TOWN OF JACKSON PLANNING & BUILDING DEPARTMENT

TRANSMITTAL MEMO

665 S. Cache

Development Permit Application

L0.4
PLANNING PLAN

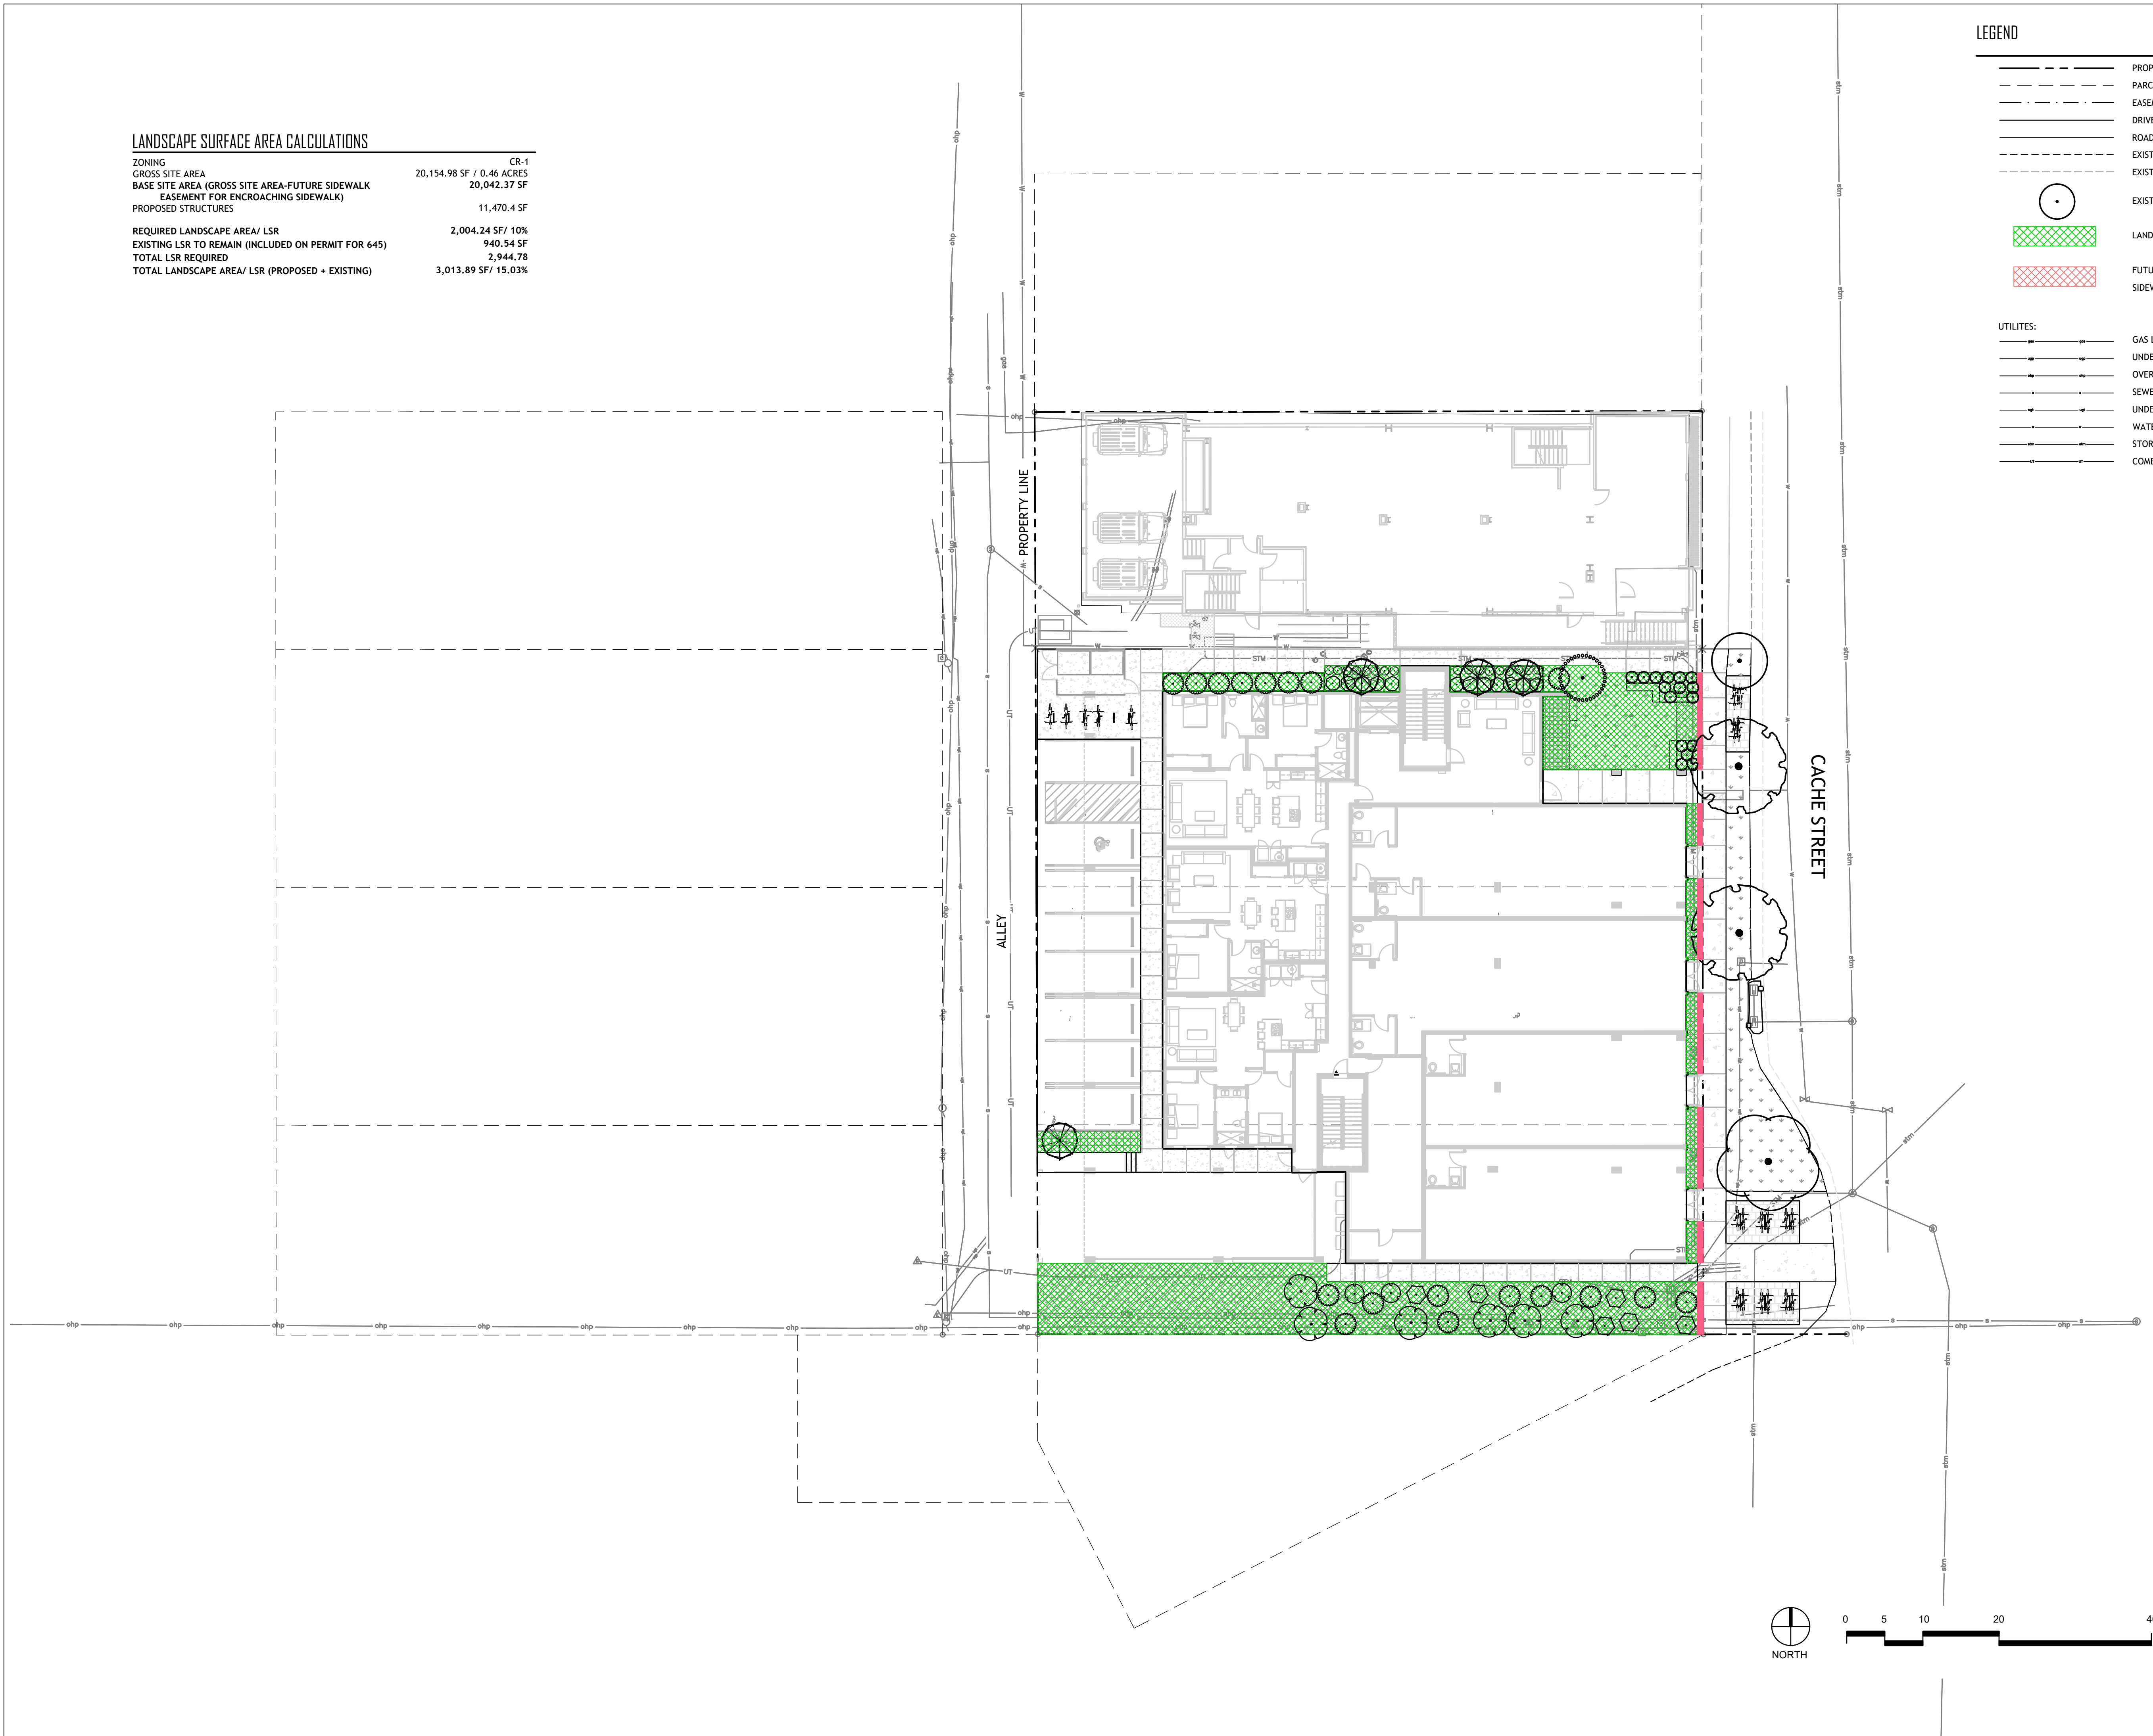
Landscape conceptual represents stepping pavers to connect the sidewalk with road access in the planter strip. Request evaluation of tree locations in the planter strip, most are immediately adjacent to stepping pavers. Request minimum 4' between base of tree and stepping pavers to avoid infrastructure impacts.

Request that planter strip be 6' minimum width to accommodate the Town's smallest acceptable street tree species (Thornless Hawthorn/Hackberry/Autumn Blaze Maple). Other larger species will require additional space beyond 6'.

- Stepping pavers have been removed from the site/landscaping plans.

- Per communication with TOJ Planning staff, 6' sidewalk with 5' planting strip to comply with "Trees in Lawn" frontage has been provided.

THIRD FLOOR PLAN

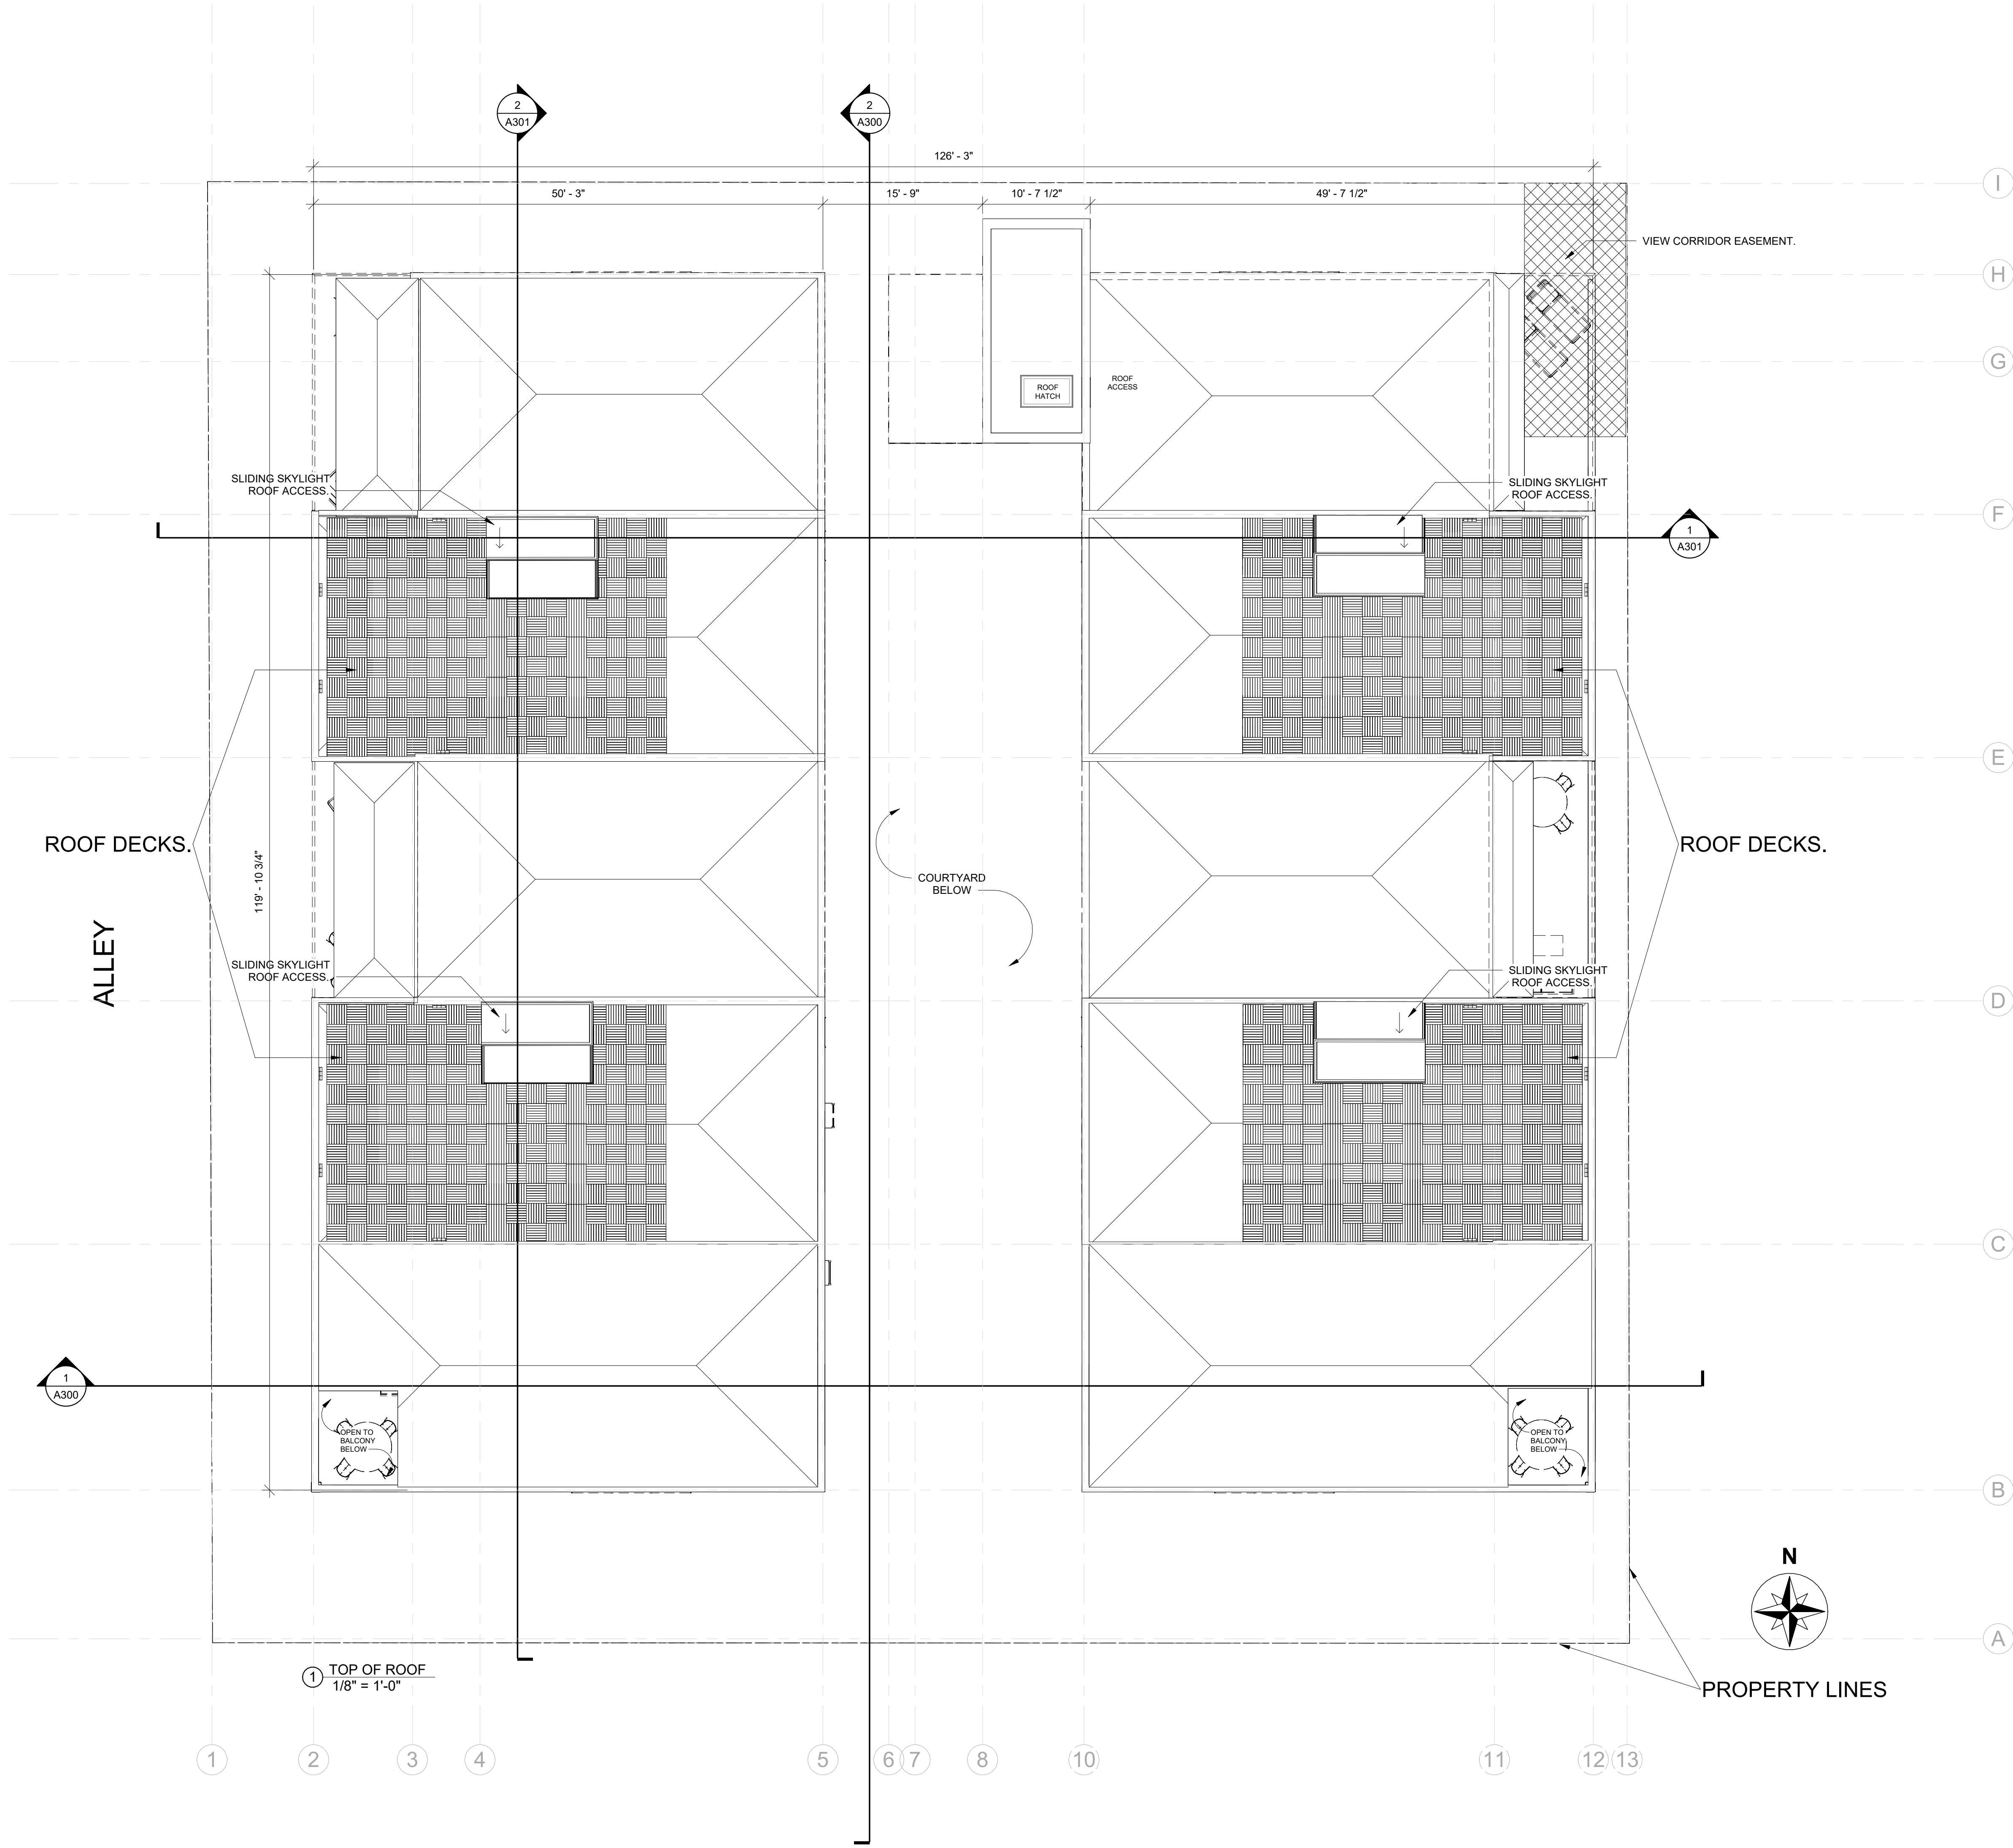
- 6. Dev. Plan submittal shall show compliance with *view corridor easement* benefiting unit 301 at 645 S. Cache. Show how 645 and 655 S. Cache building is in compliance with easement**

- View corridor easement shown as described in easement language on 3rd Level floor plan and East elevation (A104 & A201).
